FORM APPROVED
OMB NO: 1004-0137
Expires: January 31, 2018**SUNDRY NOTICES AND REPORTS ON WELLS**
*Do not use this form for proposals to drill or to re-enter an abandoned well. Use form 3160-3 (APD) for such proposals.*5. Lease Serial No.
NMLC063875A

7. If Unit or CA/Agreement, Name and/or No.
891000303X8. Well Name and No.
POKER LAKE UNIT 27 BD 121H9. API Well No.
30-015-46264-00-X110. Field and Pool or Exploratory Area
PURPLE SAGE-WOLFCAMP (GAS)11. County or Parish, State
EDDY COUNTY, NM**SUBMIT IN TRIPLICATE - Other instructions on page 2**1. Type of Well
☒ Oil Well ☐ Gas Well ☐ Other2. Name of Operator
XTO PERMIAN OPERATING LLC
Contact: KELLY KARDOS
E-Mail: kelly_kardos@xtoenergy.com3a. Address
6401 HOLIDAY HILL ROAD BLDG 5
MIDLAND, TX 797073b. Phone No. (include area code)
Ph: 432-620-4374

XTO Permian Operating, LLC requests permission to make the following changes to the original APD:

Poker Lake Unit 27 Brushy Draw 121H

13-3/8" x 9-5/8" x 5-1/2" 10M RSH-2 Wellhead
Assembly, With T-EBS-F Tubing Head

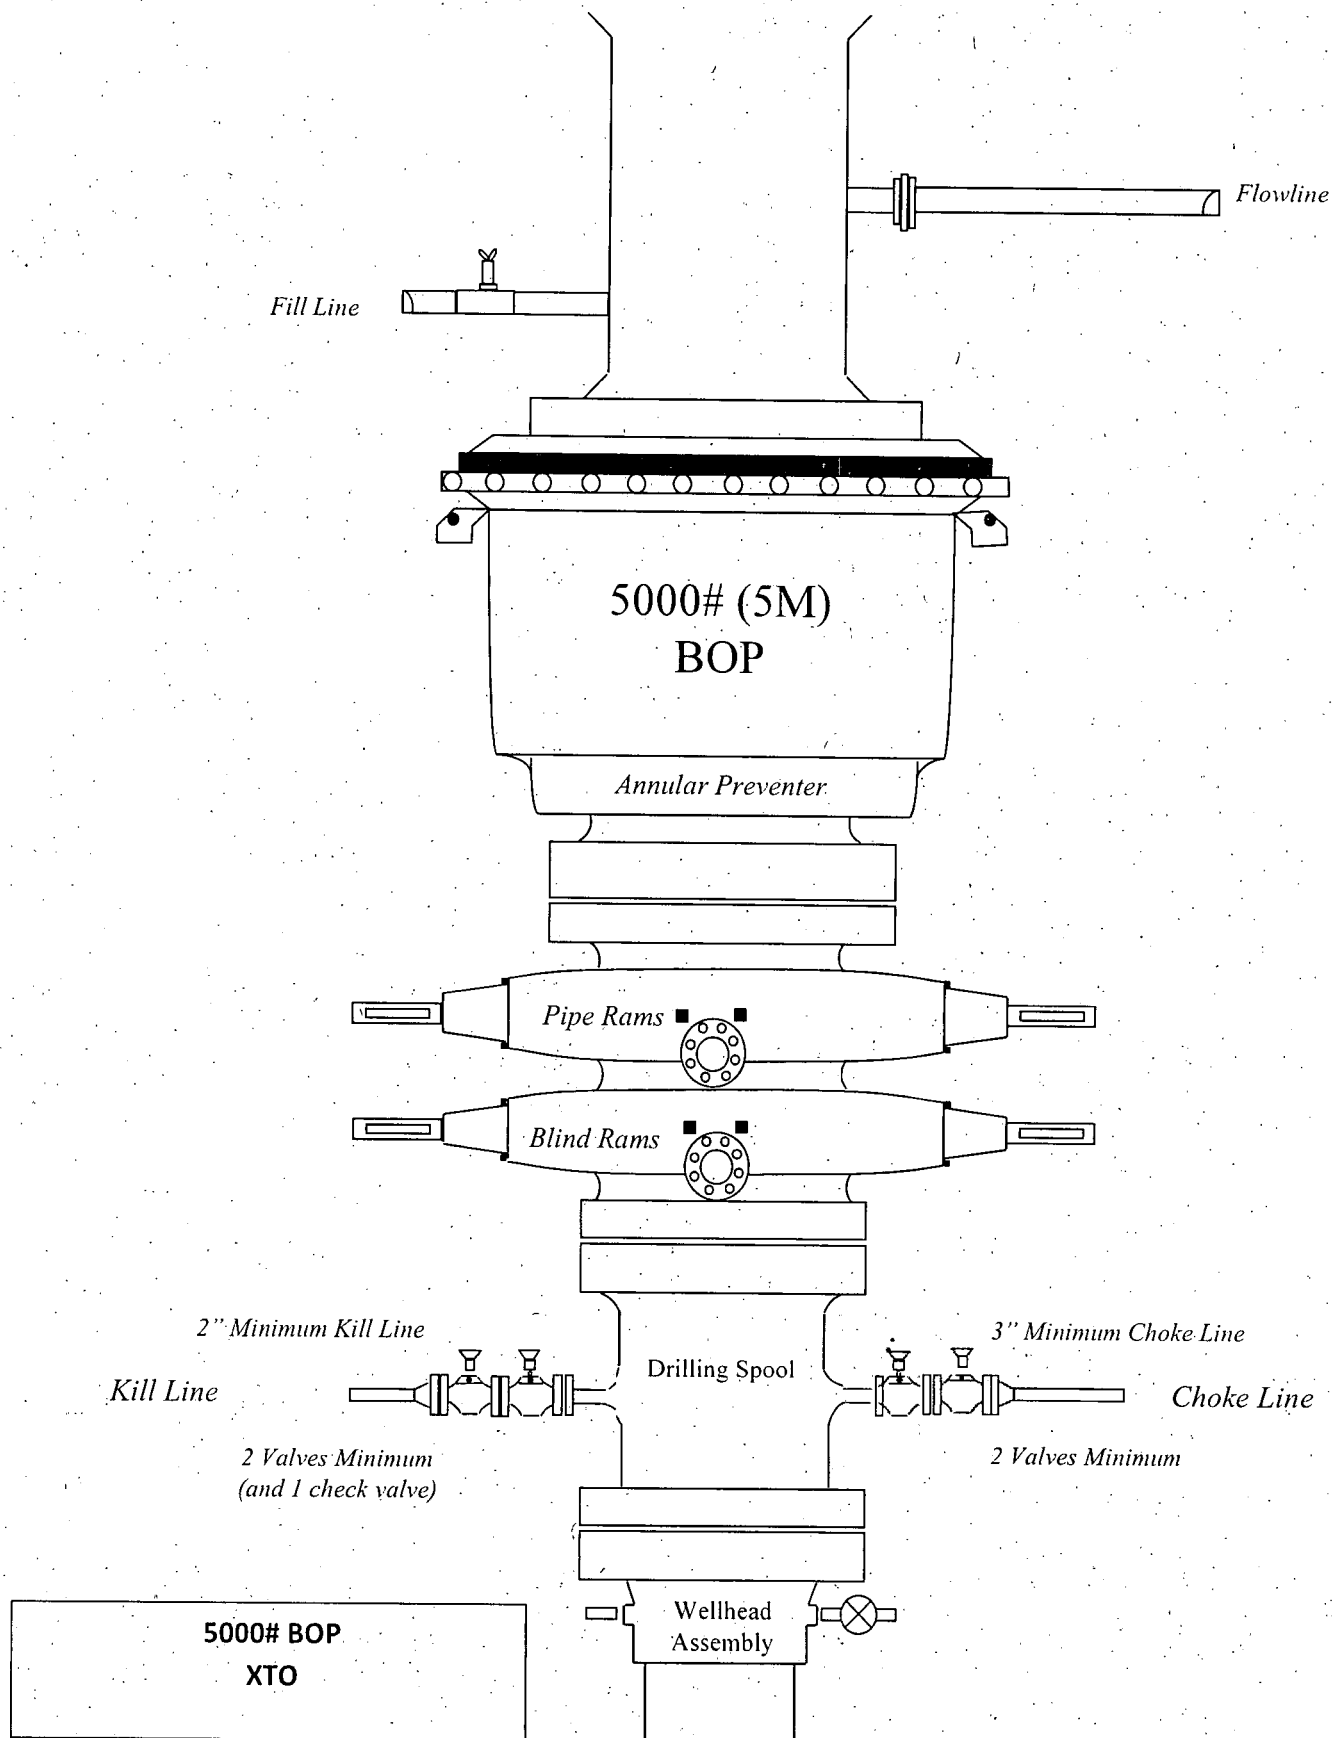
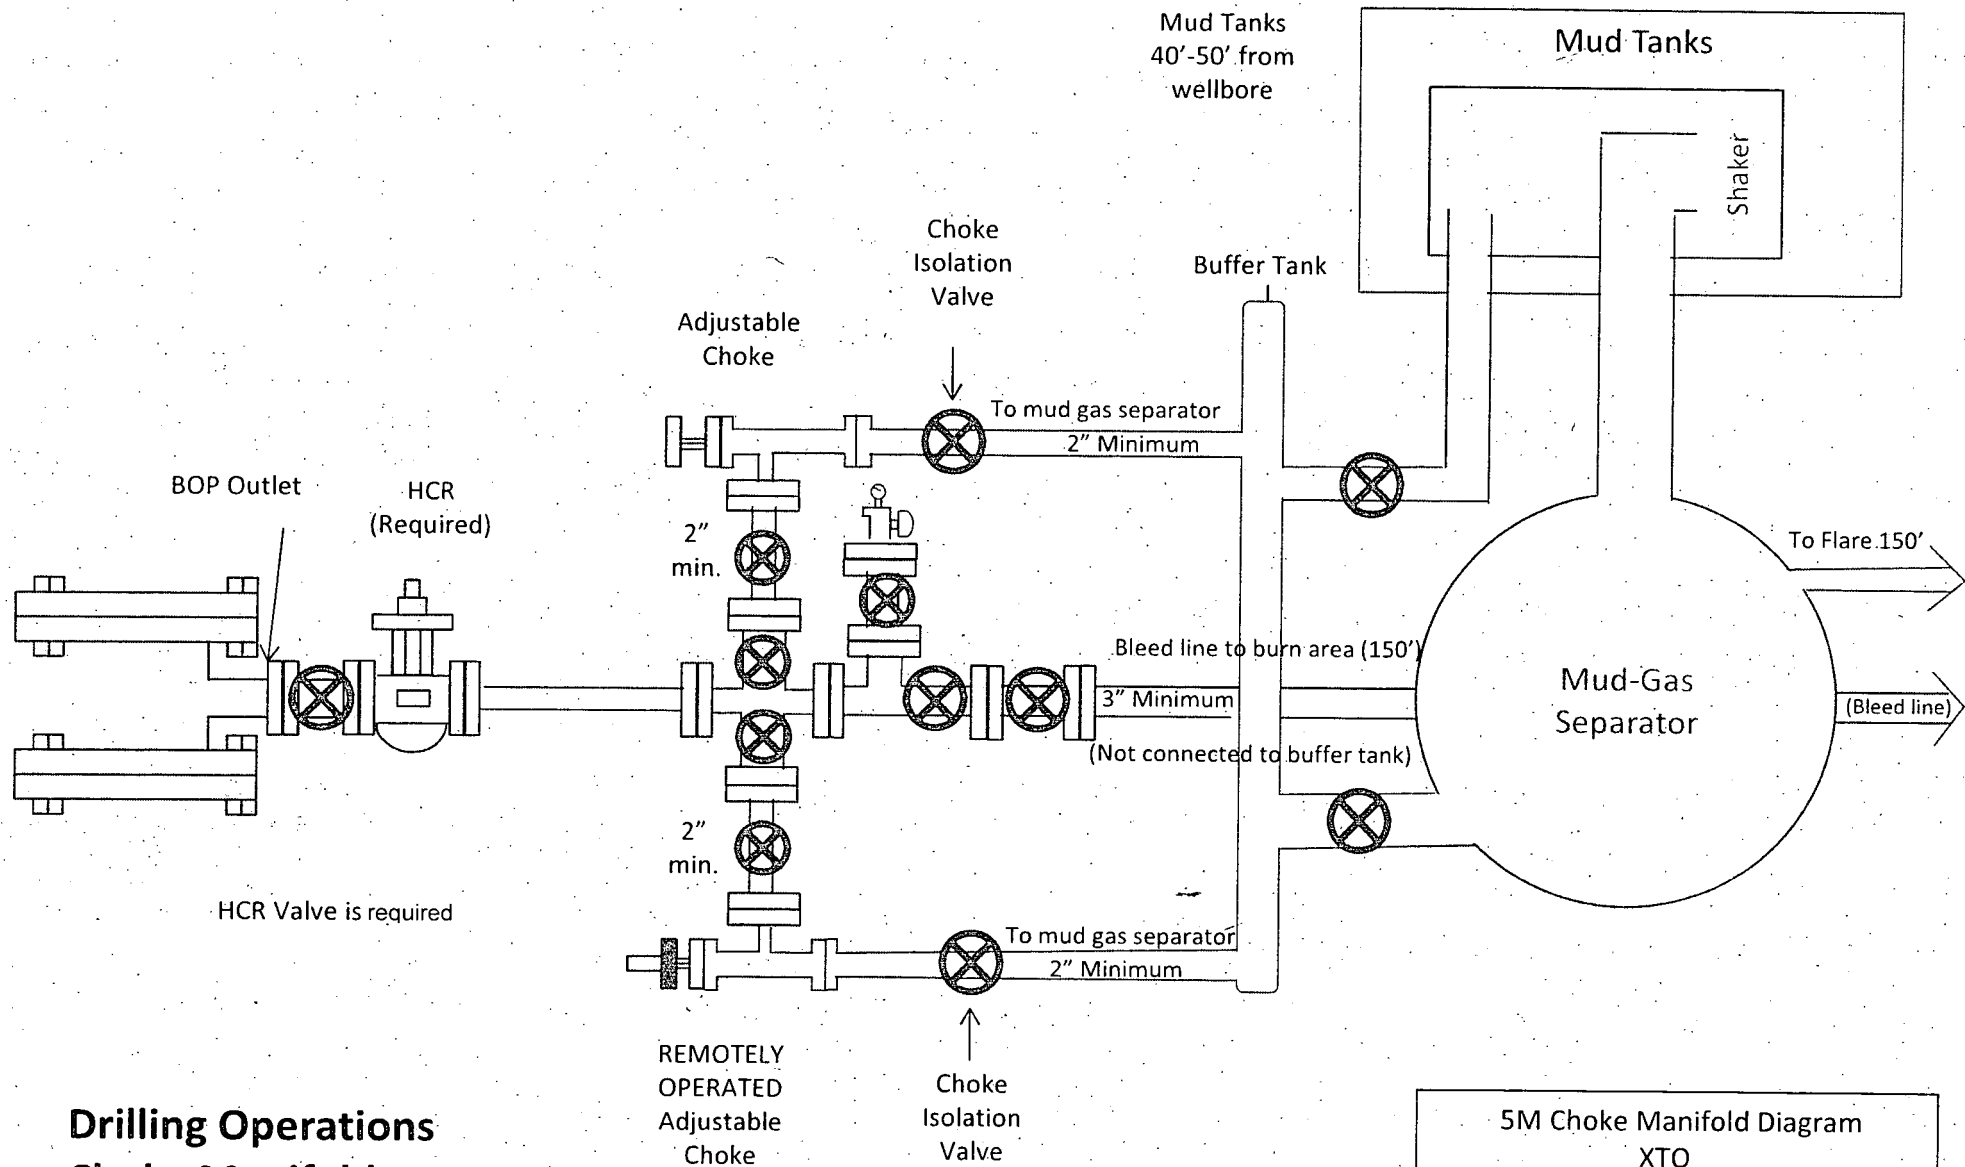
Permanent Wellhead - GE RSH Multibowl System

A. Starting Head: 13-5/8" 10M top flange x 13-3/8" SOW bottom

B. Tubing Head: 13-5/8" 10M bottom flange x 7-1/16" 15M top flange

Wellhead will be installed by manufacturer's representatives.

Manufacturer will monitor welding process to ensure appropriate temperature of seal.

Wellhead Manufacturer representative will not be present for BOP test plug installation

3. **Operator has proposed a multi-bowl wellhead assembly. This assembly will only be tested when installed on the surface casing. Minimum working pressure of the blowout preventer (BOP) and related equipment (BOPE) required for drilling below the surface casing shoe shall be 5000 (5M) psi.**

- a. **Wellhead shall be installed by manufacturer's representatives, submit documentation with subsequent sundry.**
 - b. **If the welding is performed by a third party, the manufacturer's representative shall monitor the temperature to verify that it does not exceed the maximum temperature of the seal.**

- c. **Manufacturer representative shall install the test plug for the initial BOP test.**
 - d. **Operator shall perform the intermediate casing integrity test to 70% of the casing burst. This will test the multi-bowl seals.**

GRADE D PRESSURE TEST CERTIFICATE

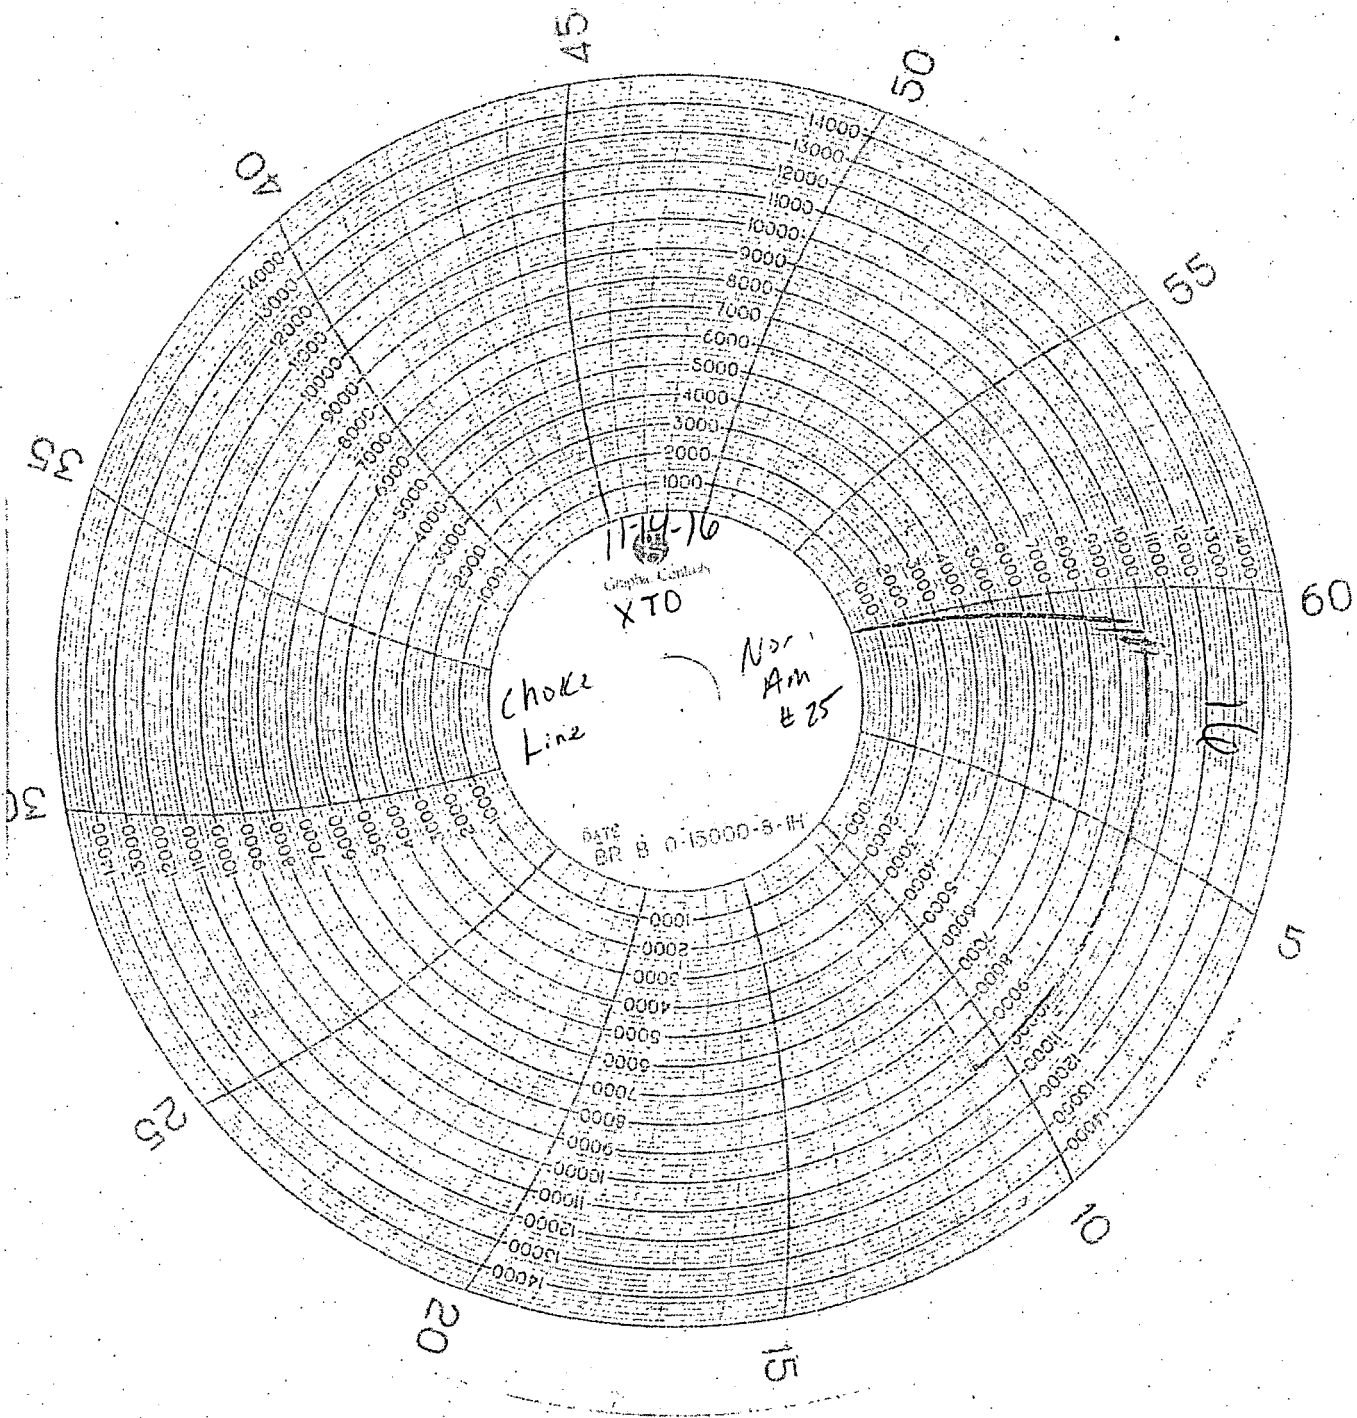
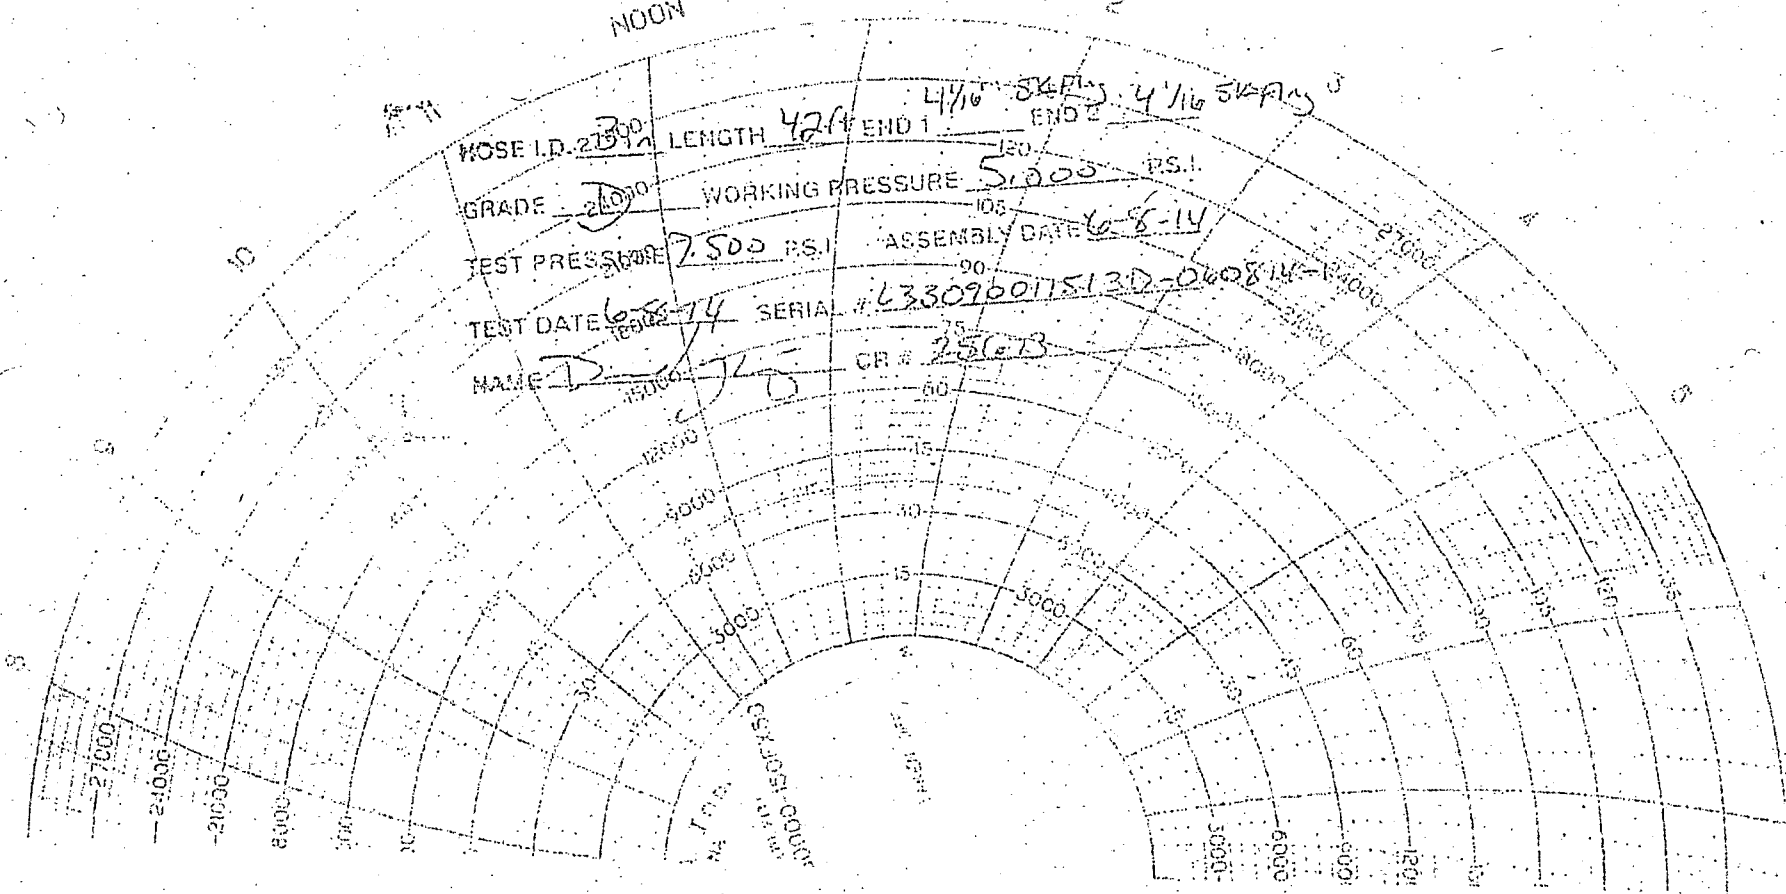
A variance is requested to allow use of a flex hose as the choke line from the BOP to the Choke Manifold. If this hose is used, a copy of the manufacturer's certification and pressure test chart will be kept on the rig. Attached is an example of a certification and pressure test chart. The manufacturer does not require anchors.

2. Variance approved to use flex line from BOP to choke manifold. Check condition of flexible line from BOP to choke manifold, replace if exterior is damaged or if line fails test. Line to be as straight as possible with no hard bends and is to be anchored according to Manufacturer's requirements. The flexible hose can be exchanged with a hose of equal size and equal or greater pressure rating. **Anchor requirements, specification sheet and hydrostatic pressure test certification matching the hose in service, to be onsite for review. These documents shall be posted in the company man's trailer and on the rig floor.** If the BLM inspector questions the straightness of the hose, a BLM engineer will be contacted and will review in the field or via picture supplied by inspector to determine if changes are required (operator shall expect delays if this occurs).
